# UNITED STATES PATENT AND TRADEMARK OFFICE

10/528,342

Hans-Jurgen Tolle

<b>Office Action Summary</b>	<b>Application No.</b> 10/528,342	<b>Applicant(s)</b> TOLLE ET AL.	
	<b>Examiner</b> NAISHADH N. DESAI	<b>Art Unit</b> 2834

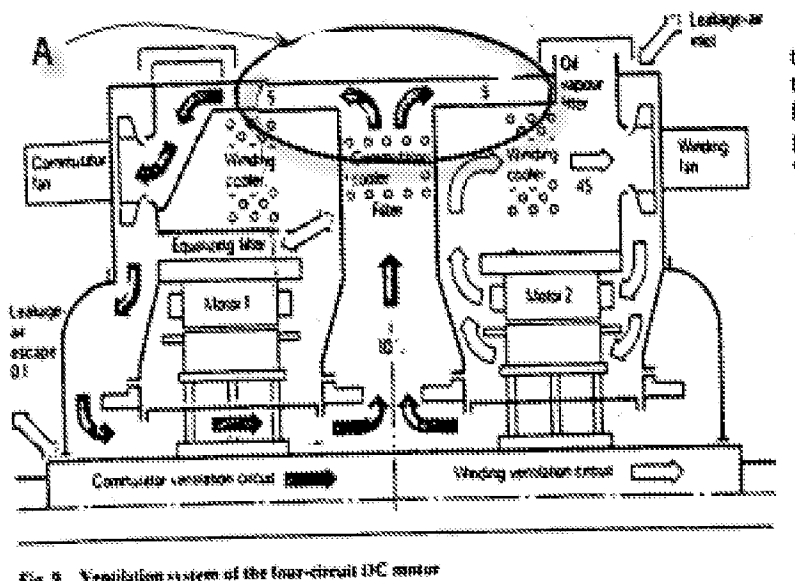
a first cooling circuit and a second cooling circuit, adapted to transport thermal energy away from the electric submarine drive motor, wherein coolant of the first cooling circuit and coolant of the second cooling circuit are adapted to flow in counter current (Fig 9) through a stator cooling ring of the electric submarine drive motor, in a region of the electric submarine drive motor (Fig 9 and Fig 9,A below and page 100 Col 1 ll 1-7).

Regarding claim 1 above, Heine et al teaches a motor to be used in a submarine. Heine et al do not appear to literally teach that the motor is using liquid cooling. Garis (abstract and Fig 3,56 and Col 6 ll 27-50) teaches an electric motor for submersible vessels using liquid as a coolant fluid. It would have been obvious to a person having ordinary skills in the art at the time the invention was made to combine the teachings of Heine et al with Garis to make a motor having redundant cooling circuits using liquid as a coolant fluid. The motivation to do so would be that it would allow for improved and more efficient cooling of the device.
